Product Change Notice (PCN)

PCN Number: PCN-0450994R-01

SJ1-3553NG, SJ1-3554NG, SJ1-3555NG, & SJ1-3555NG-BE

Description of Change:

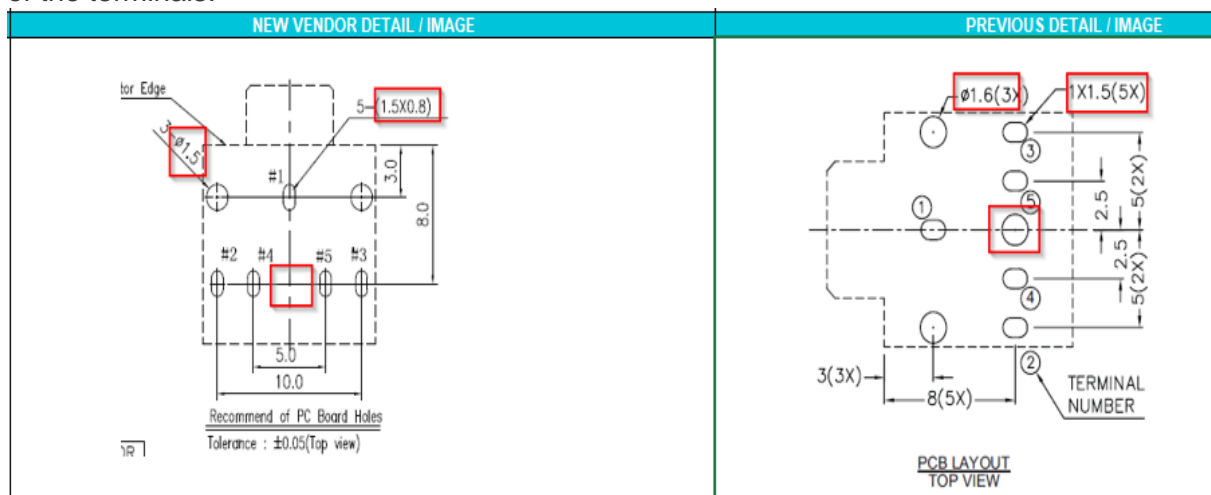
1. PCB hole recommendation differs, image does not have location feature in the back row of the terminals.

2. Terminals, and housing materials have changed

NEW VENDOR DETAIL / IMAGE				PREVIOUS DETAIL / IMAGE		
ITEM	DESCRIPTION	MATERIAL	PLATING/COLOR		MATERIAL	PLATING
1	contact foot	C2680	tin over nickel	terminal 1	brass	tin
2	contact foot	C5191	tin over nickel	terminal 2	copper alloy	tin
3	contact foot	C5191	tin over nickel	terminal 3	copper alloy	tin
4	contact foot	C2680	tin over nickel	terminal 4	brass	tin
5	contact foot	C2680	tin over nickel	terminal 5	brass	tin
6	housing	PBT (UL94V-0)		plastic	PBT	
7	cover	PBT (UL94V-0)
